SOAH DOCKET NO. 582-22-0844
TCEQ DOCKET NO: 2021-1000-MSW

IN THE MATTER OF THE	§	BEFORE THE STATE OFFICE
APPLICATION BY DIAMOND BACK	§	
RECYCLING AND SANITARY	§	OF
LANDFILL, LP FOR NEW MSW	§	
PERMIT NO. 2404	§	ADMINISTRATIVE HEARINGS

KNOX REAL PROPERTY DEVELOPMENT, LLC AND JASON HARRINGTON’S
REPLY TO EXCEPTIONS TO THE PROPOSAL FOR DECISION

Figure 1 – Application Figure III.C1.1 with Notations¹¹

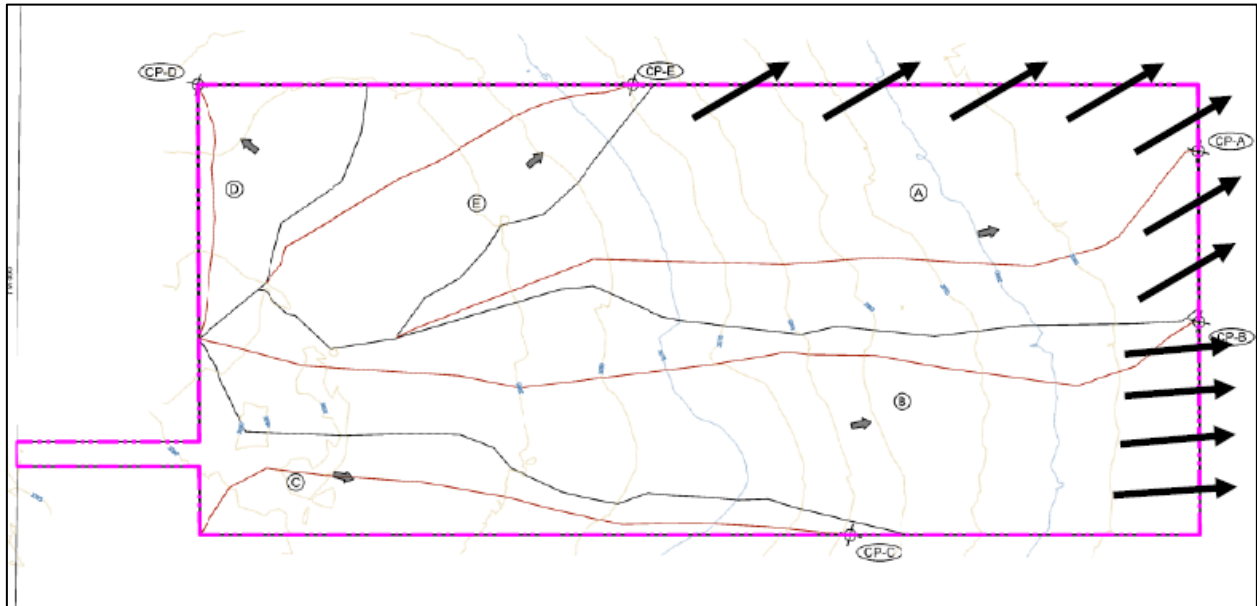
In this case, there is no dispute that under existing conditions, surface water runs off the site via overland flow—either sheet or shallow concentrated flow.⁸ In other words, surface water is exiting the site, at the perimeter, in a diffuse manner, not via a channelized flow or defined discharge route.⁹ And the water is, for the most part, exiting the eastern perimeter of the site.¹⁰

As shown in Figure 1, above, flow from the two largest drainage areas—Drainage Areas A and B—leaves the site generally via overland flow along the eastern and northeastern perimeter

To illustrate, Protestants call the Commissioners' attention to Drainage Area B and Comparison Point B, shown in the figures above. Under existing conditions, surface water from Drainage Area B exits the site as overland flow, along the southeastern perimeter of the site. But Diamond Back has assumed that the surface water from Drainage Area B leaves the site only at Comparison Point B. Thus, Diamond Back assigned the calculated peak flow rate for Drainage Area B to this one discharge point location, when, in reality, the peak flow occurs all along the southeastern permit boundary, not at this one discharge location. Had Diamond Back

Figure 2 – Application Figure III.C2.1 with Notations¹³

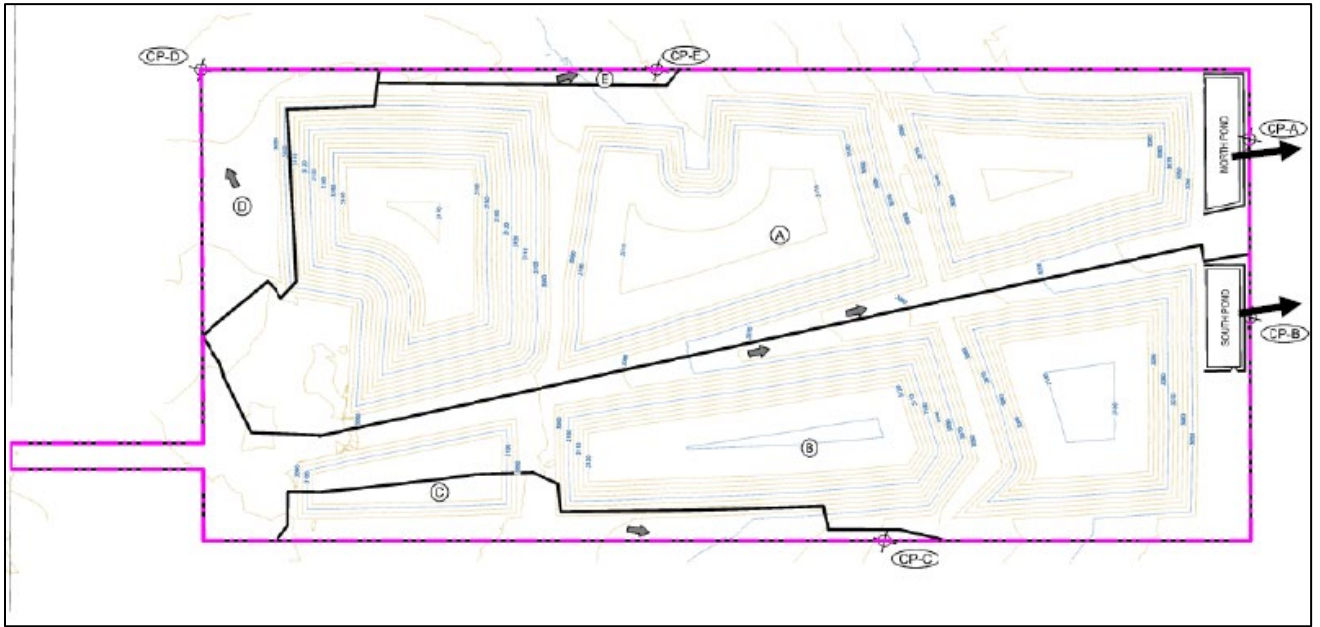
For fully developed landfill conditions, the applicant has proposed two detention ponds (North Pond and South Pond) at the eastern perimeter of the site, and intends to route surface water from two large drainage areas (Drainage Area A and Drainage Area B) to these two detention ponds where it will be discharged over weirs at these two points.¹² This is the infrastructure that

applicant has proposed to rely on for purposes of verifying that existing surface water drainage patterns will not be adversely altered.

The first issue with Applicant’s surface water drainage report is that Applicant failed to reliably and accurately reflect existing surface water drainage conditions in its analysis. In other words, Applicant’s baseline is inaccurate, which renders its comparison to proposed fully developed landfill conditions inaccurate. This, in turn, means that the Applicant cannot demonstrate that existing drainage patterns will not be adversely altered by the proposed landfill.
